# **A12 Chelmsford to A120 widening scheme**

**TR010060**

## **DEVELOPMENT CONSENT ORDER CHANGE APPLICATION**

### **Change Application Summary Report**

**Plate 2.1 Before and after image of Change One (Highway Design)**

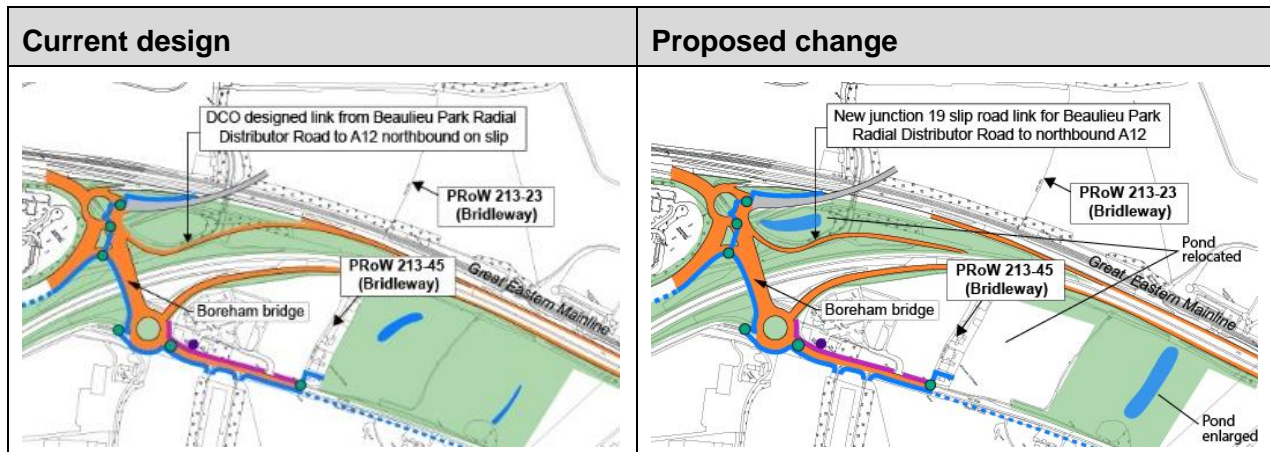
- 2.2.1 In the DCO Application, traffic wanting to travel between the Beaulieu Park Radial Distributor Road and the northbound A12 would use a segregated left-turn lane, which connected to the existing Junction 19 Northbound On-slip Road. This merge was proposed to use an offside merge, which would require traffic to join the offside lane 2 of the Junction 19 Northbound On-slip Road.
- 2.2.2 It is proposed that this arrangement could be improved by connecting the link from the Beaulieu Park Radial Distributor Road directly to the A12 northbound carriageway. This proposed merge will be more conventional, in that the merging slip road would join the nearside lane 1 of the A12.

- 2.2.3 The proposed new merge is sufficiently far from the existing junction merge and overall improves safety for road users due to the more conventional layout. There are no changes to the arrangement for walkers, cyclists or horse riders as a result of this refinement. There are consequential changes to the utility diversions in this area including the removal of the diversion of a buried water main that is no longer required.

- 2.2.4 Due to the alteration in the northbound on-slip road configuration, which is now proposed to connect directly to the A12 mainline, it is possible to reduce the size of the catchment for S1-OU11 such that it can be combined with the adjacent S1-OU12 catchment. This means that the proposed attenuation pond draining the S1-OU11 catchment can be removed. To facilitate this change, the pond draining S1-OU12 catchment will be made bigger and a new attenuation storage pond (i.e. attenuation pond S1-OU1A) will be provided to the north west of the Junction 19 northbound on slip.

- 2.2.5 By removing pond S1-OU11 and the associated access track, it is possible to reduce the extent of land plot 2/12g which is subject to permanent acquisition. Some of the land no longer subject to permanent acquisition, will be required temporarily to facilitate construction and permanent access rights will be required to provide a route to maintain the vegetation and ditches adjacent to the proposed Paynes Lane bridge and A12 embankments. The updated land plan regarding the above described change is provided within Map Book 1 [TR010060/EXAM/10.5], submitted with DCO Change Application

- 2.2.6 This design change is illustrated in Figure 2.1, and Map Book 1 – Junction 19 Slip Road - Part 1 of 1 [TR010060/EXAM/10.5].
- 2.2.7 While the consultation materials for the Change Application indicated that there may be consequential amendments to the drainage design at junction 19, the detail of that amended design did not form part of the consultation materials. However, the amended drainage design has been assessed as part of the environmental assessment carried out for the proposed changes and contained within the Environmental Statement Addendum submitted with the Change Application. Further, refining the drainage design allows the Applicant to address a concern raised by an affected landowner, that was received in response to the consultation, asking the Applicant to consider whether the drainage design could be refined to reduce the amount of land take proposed on their land.

**Plate 2.2 Before and after image of proposed Change Two**

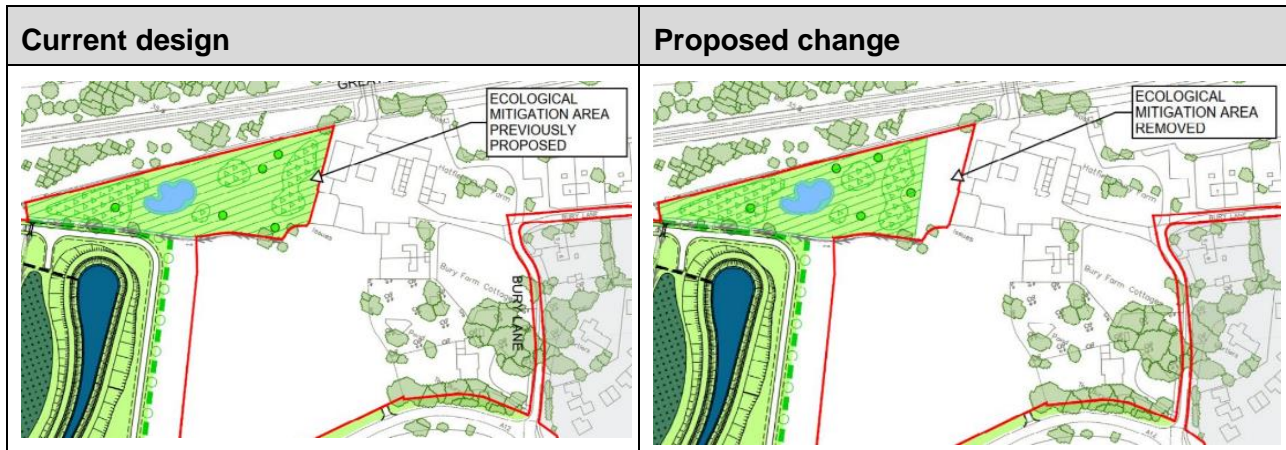
- 2.3.1 The proposed change is to the extent of an Environmental Mitigation Area as shown on the General Arrangement Drawings (Map Book 2) [TR010060/EXAM/10.6] to accommodate a pumping station at the Bellway Homes Site, Hatfield Bury Farm, Bury Lane, Hatfield Peverel (planning permission 19/01803/FUL). This falls within the Order Limits of the proposed scheme and specifically land plot 5/12c as shown on Sheet 5 of the Land Plans [APP-018].
- 2.3.2 The Applicant proposes to change the land use at this location from compulsory acquisition for ecological mitigation, to, land not subject to powers of compulsory acquisition or temporary possession. The small area of ecological

mitigation that will be lost is a negligible decrease in the overall land being provided for ecological mitigation across the whole proposed scheme.

2.3.3 This design change is illustrated in Figure 2.2 and shown on Map Book 2 – Anglian Water Pumping Station (Bury Lane, Hatfield Peverel) - Part 1 of 1 [TR010060/EXAM/10.6].

**Plate 2.3 Before and after image of proposed Change Three**

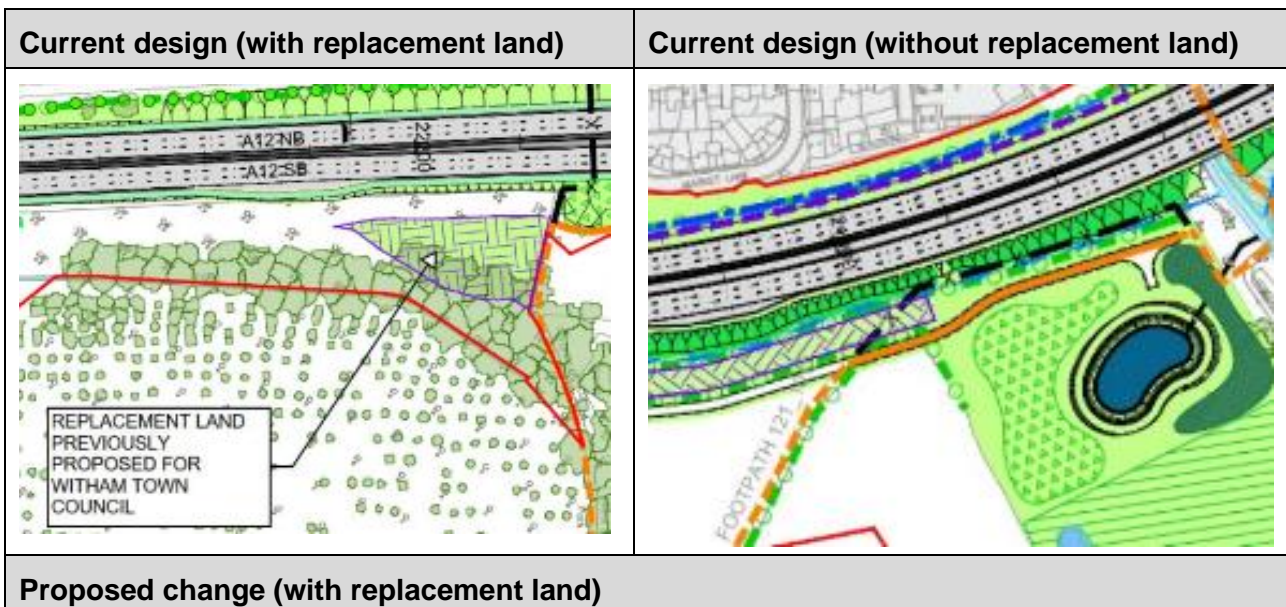
2.4.1 The Applicant has been made aware of a transfer of the freehold of parts of the open space land identified as being in Braintree District Council's freehold ownership, with the land being transferred to Witham Town Council. The transfer has not been registered at HM Land Registry as yet.

- 2.4.3 The Applicant has also taken the opportunity to slightly alter the replacement land proposed to be provided to Witham Town Council. The land now proposed is near to the existing Whetmead Local Nature Reserve. The owner of the land being provided as replacement land will be consulted on this change. Again, no additional land is required, simply the purposes for which the land is being used has changed.

- 2.4.6 This change is illustrated in Figure 2.3 and shown on Map Book 3 – Replacement Land, Witham - Part 1 of 1 [TR010060/EXAM/10.7].

**Plate 2.4 Before and after image of proposed Change Four**

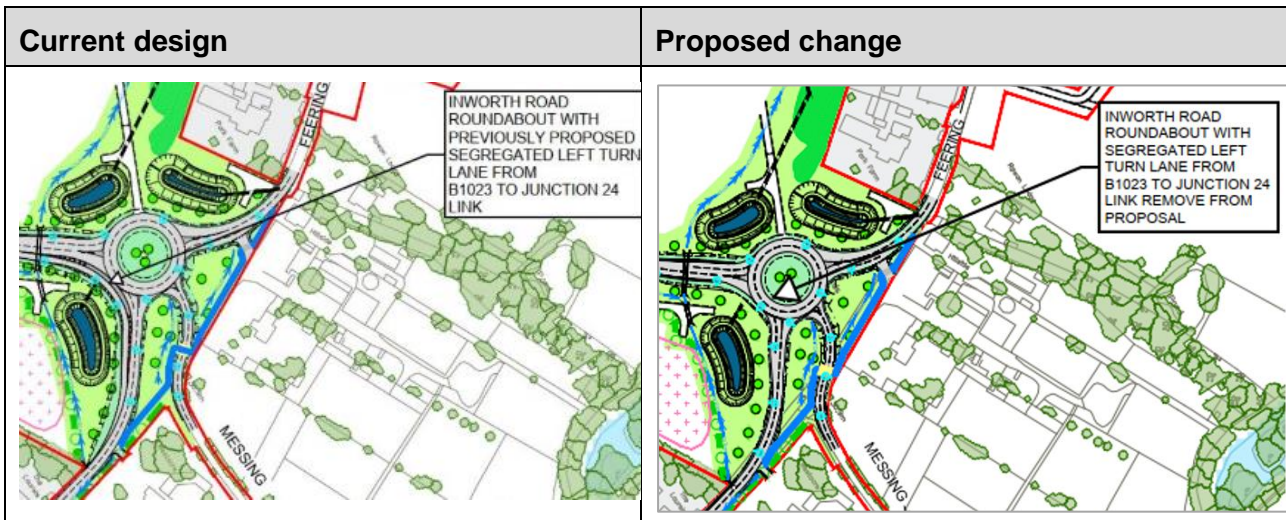
- 2.5.1 Discussion took place at Issue Specific Hearing 1 regarding the changed design to the roundabout on the B1023 linking to the approach to the newly proposed junction 24. This design previously consisted of a separate left turn lane (SLTL) for traffic approaching from the south along the B1023 and turning left to reach junction 24.

- 2.5.2 Through refinement of the design and validation against the strategic traffic model presented as part of the DCO Application, its inclusion is not required for the roundabout to perform acceptably in the proposed scheme's design year of 2042. Further to this, the proposed removal of the SLTL helps reinforce the local nature of the existing B1023 in this area, reduces the area of impermeable pavement and therefore the drainage burden in the immediate vicinity.

2.5.4 This design change is illustrated in Figure 2.4 and shown on Map Book 4 – B1023 Flood Mitigation and Drainage - Part 1 of 1 [TR010060/EXAM/10.8].

**Plate 2.5 Before and after image of proposed Change Five**

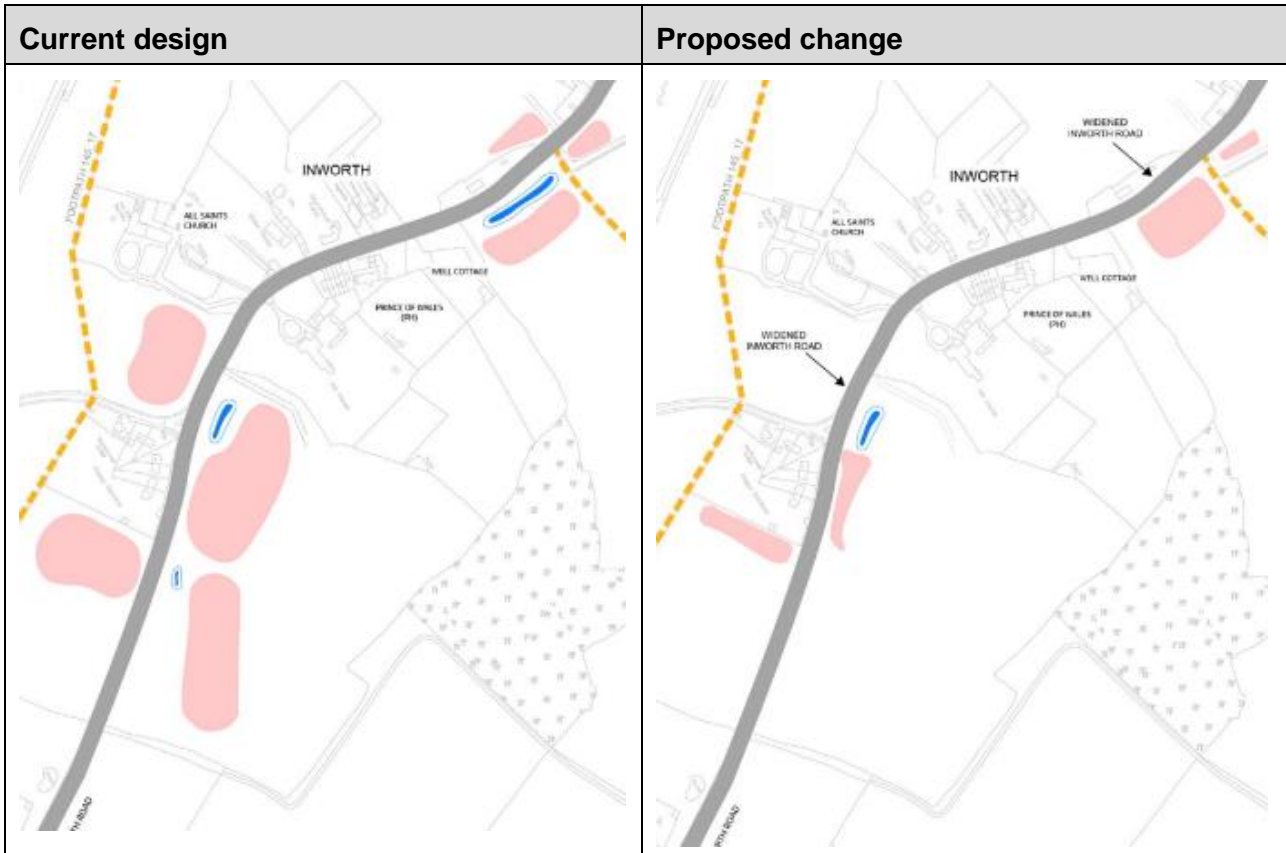
- 2.6.2 The following alterations have been applied to the Works plans and descriptions:
- a. Changed descriptions and areas of works:
    - i. Work No. 114 - flood mitigation area removed; ditch retained

- i. Work No. 120 - will only comprise one flood mitigation area, rather than two
  - b. Works removed:
    - i. The following works will be deleted from Schedule 1 and the permanent works plans, with other plans being updated accordingly:

- (i). Work No. 115
      - (ii). Work No.118
      - (iii). Work No. 121
- 2.6.3 This design change is illustrated in Figure 2.5 and shown on Map Book 5 – B1023 Roundabout - Part 1 of 1 [TR010060/EXAM/10.9].

**Plate 2.6 Before and after image of proposed Change Six**

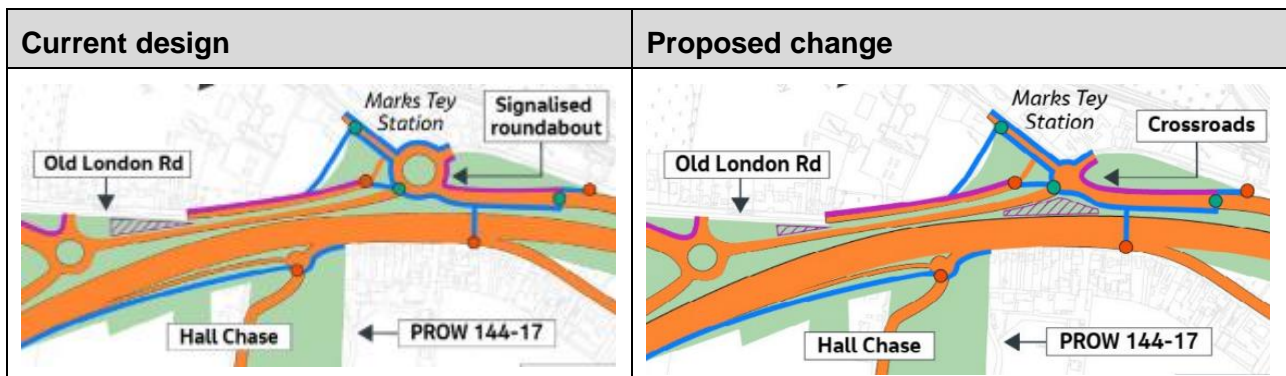
- 2.7.2 The retention of the roundabout, albeit with its signalisation, requires less land acquisition and has small impacts on the proposals for replacement land in this location. The replacement land located along Old London Road will be extended to accommodate this change.

- 2.7.3 Materially different effects arise for the proposed change at junction 25, as seven properties would no longer be predicted to be subject to significant adverse noise effects along London Road, through Copford. The change also has the positive impact of reducing the amount of tree felling required for the proposed scheme to proceed.

- 2.7.5 This design change is illustrated in Figure 2.6 and shown on Map Book 5 – B1023 Roundabout - Part 1 of 1 [TR010060/EXAM/10.9].
